Device **C504-2E**
Marking/Step **Step CA**
Package **P-MQFP-44**

This Errata Sheet describes the deviations from the current user documentation.

- C504 User's Manual 11.97
- C504 Data Sheet May 2000
- Instruction Set Manual 07.2000

Figure 1 Reset Circuitries

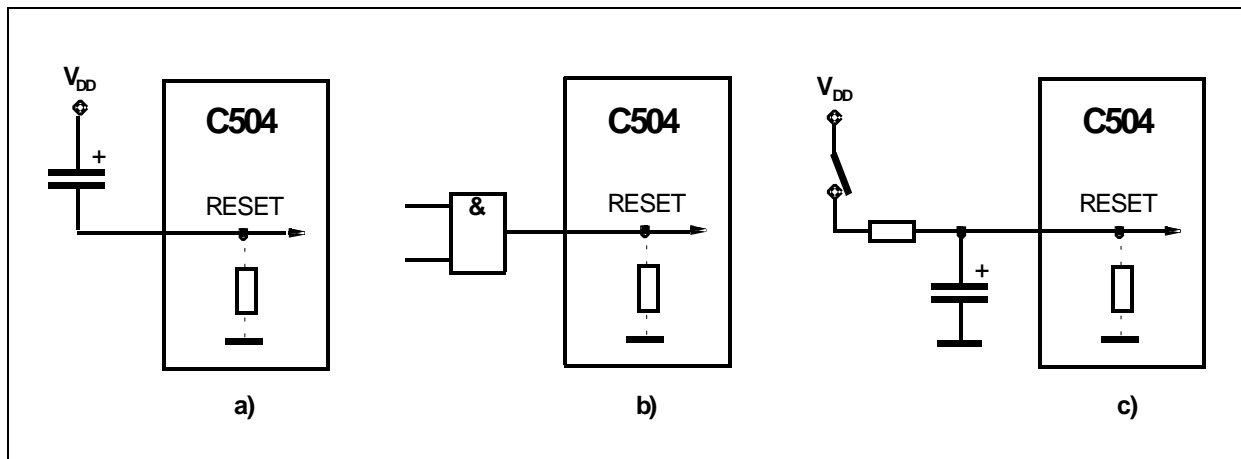
RST.1: Figure in User’s Manual and Data Sheet regarding the Reset Circuitries is incorrect

Figure 5-1 in User’s Manual and Figure 6 in Data Sheet show incorrectly that the RESET pin has an internal pullup resistor connected to the V_{DD} . Instead, at the RESET pin, an internal pulldown resistor is connected to the V_{SS} . The correct implementation is illustrated in [Figure 1](#).

This correction will be updated to the future versions of the User’s Manual and Data Sheet.
